**NSLPP MEETING HELD ON 01/02/2023****Attachments:**

ADDRESS/WARD: 131-133 Alexander Street, Crows Nest**APPLICATION No:** DA212/22

PROPOSAL: Demolition of existing structures and construction of a four storey commercial building and a two level basement for parking and other ancillary uses, vehicular access from Alexander Lane, a rooftop seating area, landscaping and associated works.

OWNER: Central Services of Sydney Pty Ltd**APPLICANT:** Central Services of Sydney Pty Ltd**AUTHOR:** Jim Davies, Executive Planner**DATE OF REPORT:** 18 January 2023**DATE LODGED:** 19 July 2022**RECOMMENDATION:** Approval (Deferred Commencement)

Drawing Number: 12415_DA102 **Scale:** 1:100

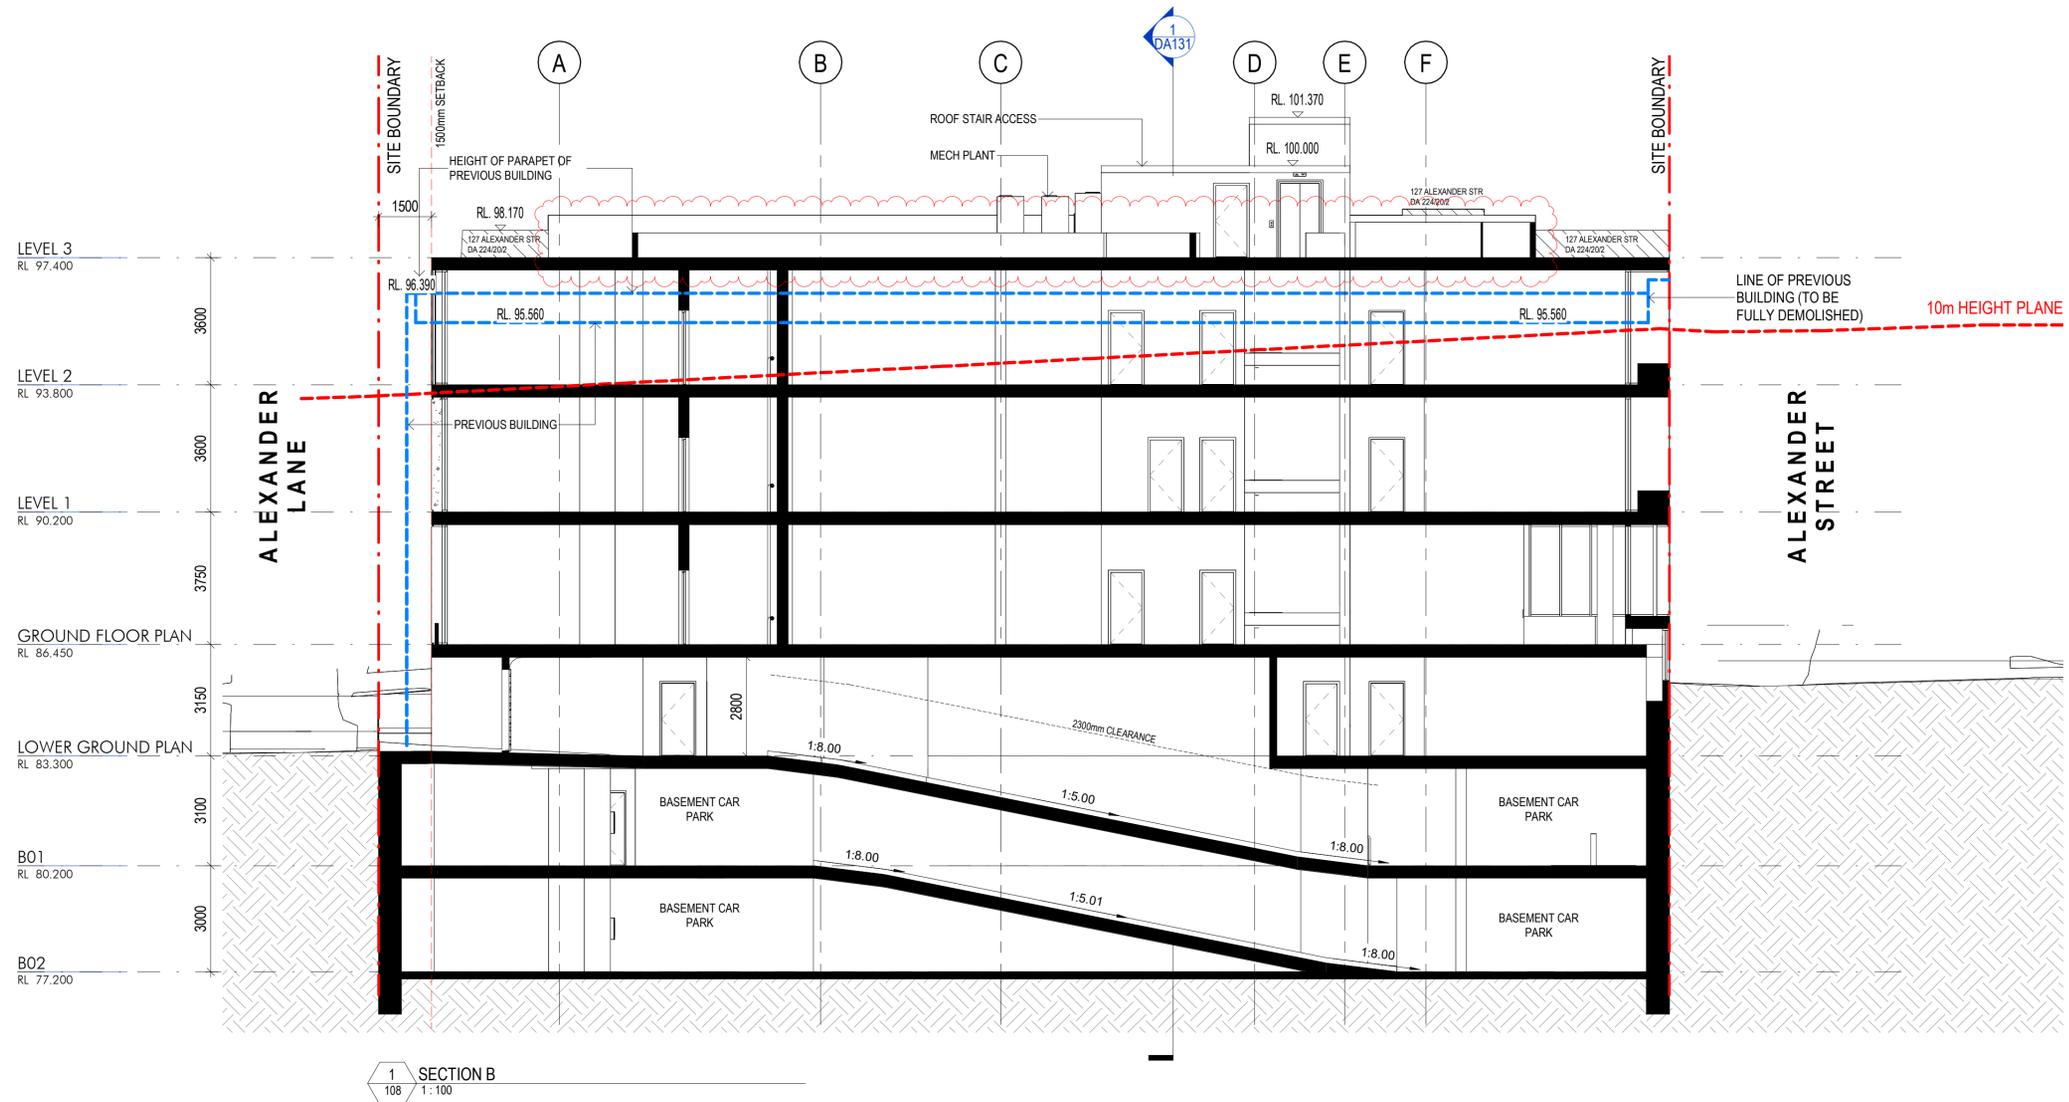
- d) Excavation and existing ground levels
- Ground levels and access to the building were considered acceptable at the front of the building.
 - To the rear, the finished levels, noting the challenge posed by the fall from south to north, was not well-resolved. The partly underground lettable space in the basement with small windows facing the lane should be improved, and the 'breakout space' and meeting rooms on the 'lower ground' level without windows should be removed (see later comments). (The windows to these spaces on the lower ground flood have been removed – see Drawing DA 102 Rev C).

1. Large areas on the lower ground floor offer poor amenity and could be deemed uninhabitable. They would have little or no natural light or ventilation. They need to be removed (made into voids and/or blocked off) or put to other purposes, such as storage, plant or other facilities. Bicycle storage and user-amenities could be all located conveniently adjacent to each other on this level.
